HUB Cycling Accessibility Assessment Ride

May 10, 2023

təmtəxw̓tən/Belcarra Regional Park and Village of Belcarra

The purpose of the ride was to assess cycling accessibility for varied types of people cycling in the park and through the village.

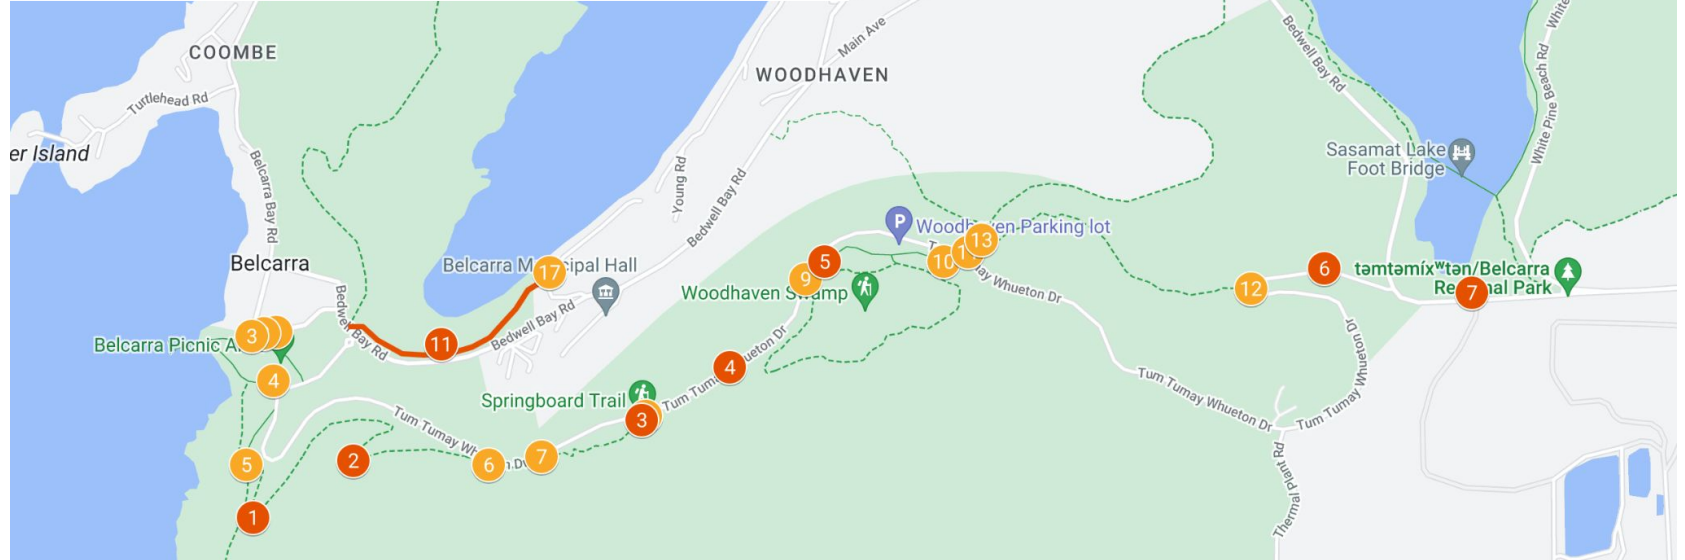
- Maze gates are being removed in Coquitlam, Surrey, North Van and other communities

- Rigid bollards are being replaced with flexible delineator posts

- We suggest Metro Vancouver Parks consider removing one or both sides of the maze gates and where needed, consider flexible delineators or signage.

Gate 3 - Park entrance at Midden Rd + Belcarra Bay Rd

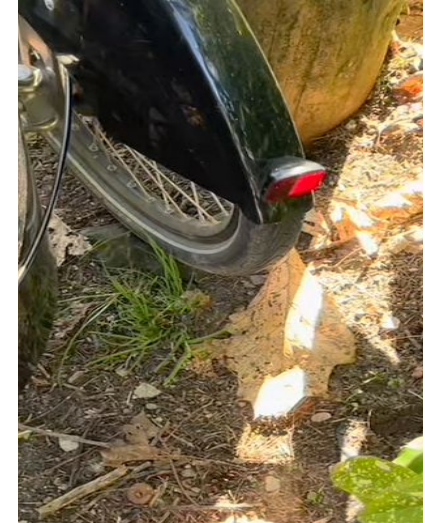
- Measurements: Left side gap is 39", right side gap is 40"
- Problem 1: cargo bike rider found the opening very tight and had to dismount to maneuver through
- Problem 2: adaptive cyclist felt openings were narrow and pointed out that the bollard and fence both posed a hand danger for him
- Recommendation: cut off fence on left side to widen gap, remove rock on right side, consider installing a flexible bollard

Rock impedes travel

Gate 7 - gate near Newt Crossing sign

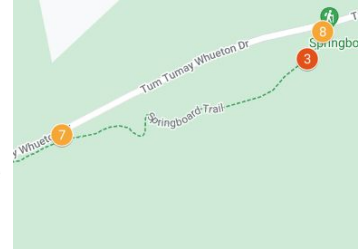
- Adaptive rider was able to enter this gate but due to the low speed he found it hard to get started up the hill
- Cargo bike rider had to dismount and wheel bike through and also found it hard to build enough speed to climb the hill
- Recommendation: a) remove both sides of the maze gate, b) consider a flexible delineator if needed or c) remove one side of the gate being aware of hand injury and tipping risks
- Observation: in 2019 there were bollards just east of the gate. Had these been left in place and both sides of the maze gate removed there would be better accessibility at this entrance, thus we recommend the gate be removed and bollards reinstated.

Gate 13 - Springboard Gate east park exit

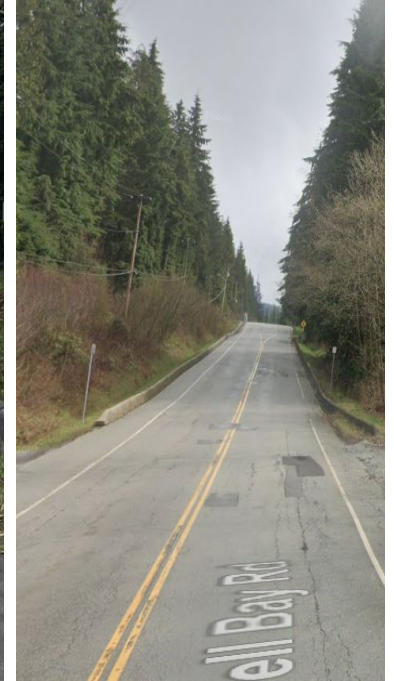
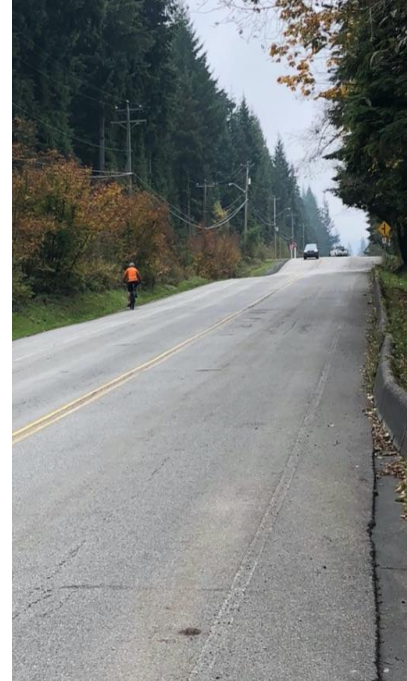
- Measurements are the same as other maze gates thus same issues
- Adaptive rider found the turning radius limited due to the rock on the left
- Adaptive rider was concerned about tipping hazard on right side
- Recommendation: Remove both maze gates as they are unnecessary as there is a bollard that does the job

Gate 14 ~ White Pine Beach - Bowser Trail east gate

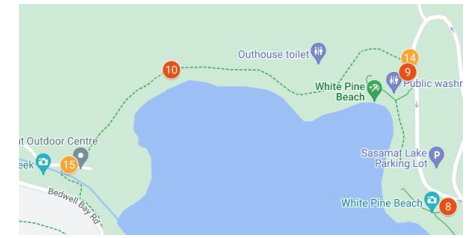
- Beach access road provides good access to beach for an adaptive bike, bollards are placed wide and there is lots of room for both the adaptive rider and cargo bike rider
- Bowser Trail access: Rock impedes passage for adaptive rider and cargo bike barely squeezes through. Rock is a hand injury issue for the adaptive rider
- Recommendation: Remove rock or tree to enlarge opening

Bedwell Bay Trail

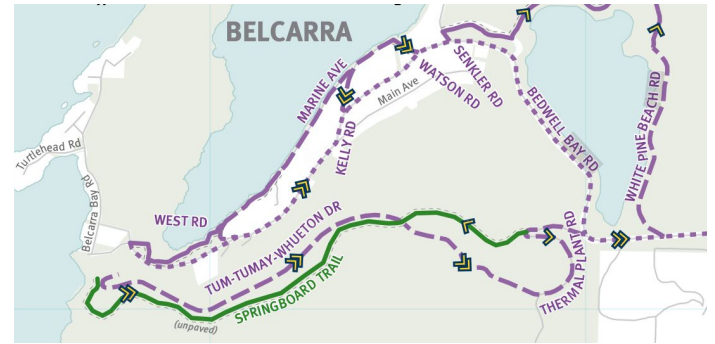
- All riders found this an easy trail as it is relatively flat, has a good crushed rock surface and a good width. The Ray Creek bridge measures 58" between the side boards. It is noted that this trail is equally as wide as many sections of the Springboard Trail.

All riders felt that this trail offers a safe accessible link, allows riders to avoid the busy, narrow and hilly Bedwell Bay Road and has less elevation gain than Springboard Trail.

Recommendation: Allow cycling on Bedwell Bay Trail and add dual-use signage.

Gate 14 - Bowser Gate west exit

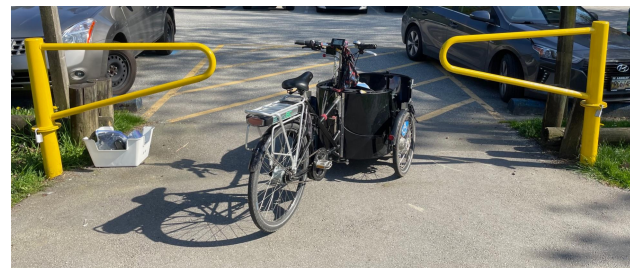
- Problem 1: Opening is narrow, hindered by tree root
- Problem 2: Stairs are too close to allow a proper turning radius
- Adaptive rider was concerned about tipping on the stairs
- Cargo bike rider couldn't ride, had to have help getting through opening and turning onto road
- Recommendation: Make gate smaller and to allow wider access, see *other gate suggestions*
